R04HV

INSTRUCTIONS FOR RECALL R04HV

REAR ROOF SHEET TO REAR ROOF CAP JOINT RIVET INSPECTION AND REPAIR PROCEDURES

Rear Roof Cap Rivets

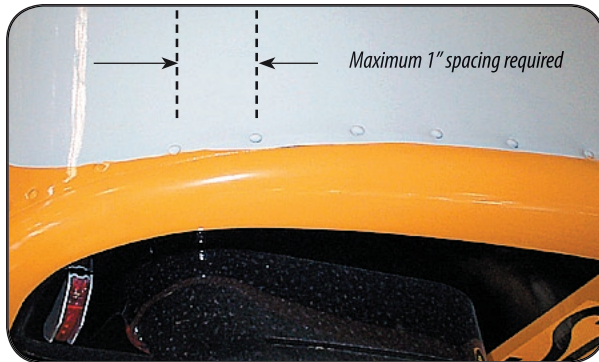
On some units, the rivet pattern may be incorrect in sections of the rear roof sheet joint which attaches to the rear roof cap, resulting in noncompliance with FMVSS 221, School Bus Body Joint Strength.

This procedure inspects the spacing of rivets at the joint and installs additional rivets as required by specification.

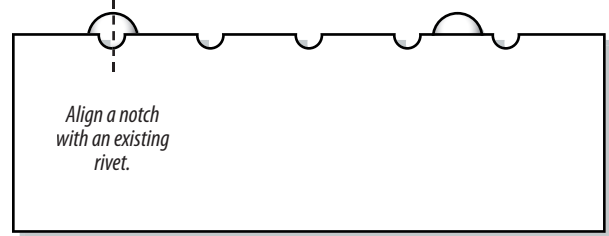
1 Inspect the rivet spacing along the joint of the rear roof sheet and the rear roof cap. Rivets must be added wherever center-to-center spacing is greater than 1 inch. A spacing template is provided to aid inspection and marking of locations for new rivets.

1.1 Align a notch of the template with a rivet on the bus. The notches of the template are spaced at the required 1-inch increments.

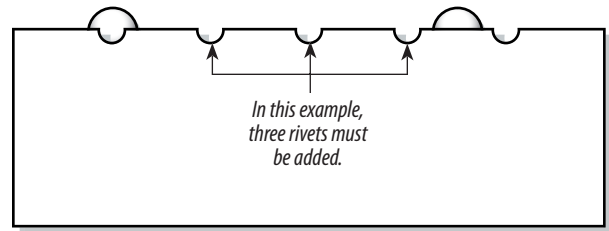
1.2 If the next notch does not reach the next rivet on the bus, at least one rivet must be added. Count the number of notches which do not have corresponding rivets on the bus. That is the number of rivets which must be added between the two existing rivets.

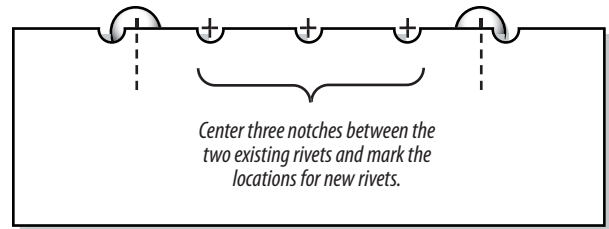
1.3 Visually center the number of required notches between the two existing rivets, and mark the locations.
